**Service
Bulletin**

**B0303011
2003-07**

Subject: Primary Drive Idler Arm & Pulley on the BAM Mower.

Engine Viewed from the Right Side

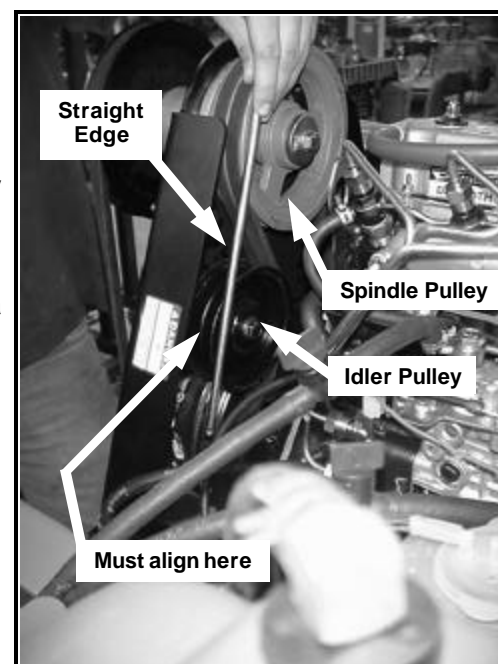
There is a possibility that the primary drive belt idler arm may be out of tolerance, allowing the idler pulley to misalign, causing the primary drive belts to prematurely wear or fray.

This can be checked visually, or it can be checked by using a straight edge. Lay the straight edge against the cast pulley on the spindle assembly above the idler. The belts must be centered in the idler pulley, and the idler pulley must in line with the cast spindle pulley.

If the idler pulley is not in alignment as described above, the idler arm is distorted and must be replaced.

The only component that should need to be replaced is the idler arm itself. All other components are transferable. Order part number . . . P/N 539 106422 . . . Idler Arm.
